User Safety Notice

FireHawk® M7XT Air Mask

December 19, 2014

2nd Stage Regulator

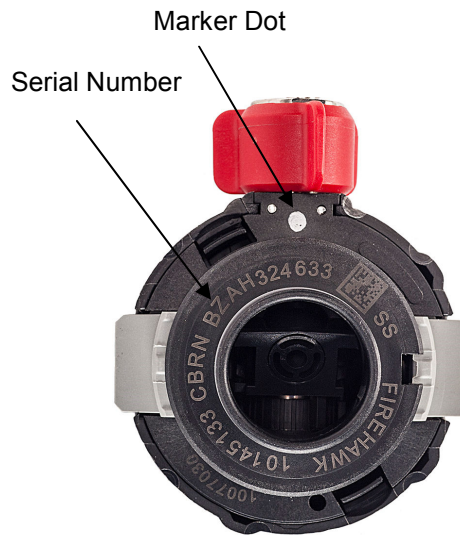
We have become aware that insufficient lubrication may have been applied to the bypass valve assemblies on FireHawk M7XT Air Masks when manufactured. A lack of sufficient lubricant could cause the bypass assembly to become difficult to operate or possibly inoperable. No injuries have been reported.

Once the inspection, cleaning, and re-lubrication or component replacement is completed, the technician will mark the regulator with a dot (as shown in the photo below) using a permanent silver marker to identify that the repairs are completed.

Affected Air Masks have a second stage regulator with any of the 10 digit serial numbers according to the list below. The serial number is etched on the underside of the regulator body as shown in the photo below:

To correct this condition and ensure the proper functioning of the FireHawk M7XT Mask-Mounted Regulator bypass valve, we have arranged for MSA CARE certified SCBA repair technicians to inspect, clean, and re-lubricate the bypass valve assembly on all FireHawk M7XT Air Masks free of charge. If during the inspection, there are signs of wear due to lack of lubrication, the valve and bypass assemblies will be replaced free of charge.
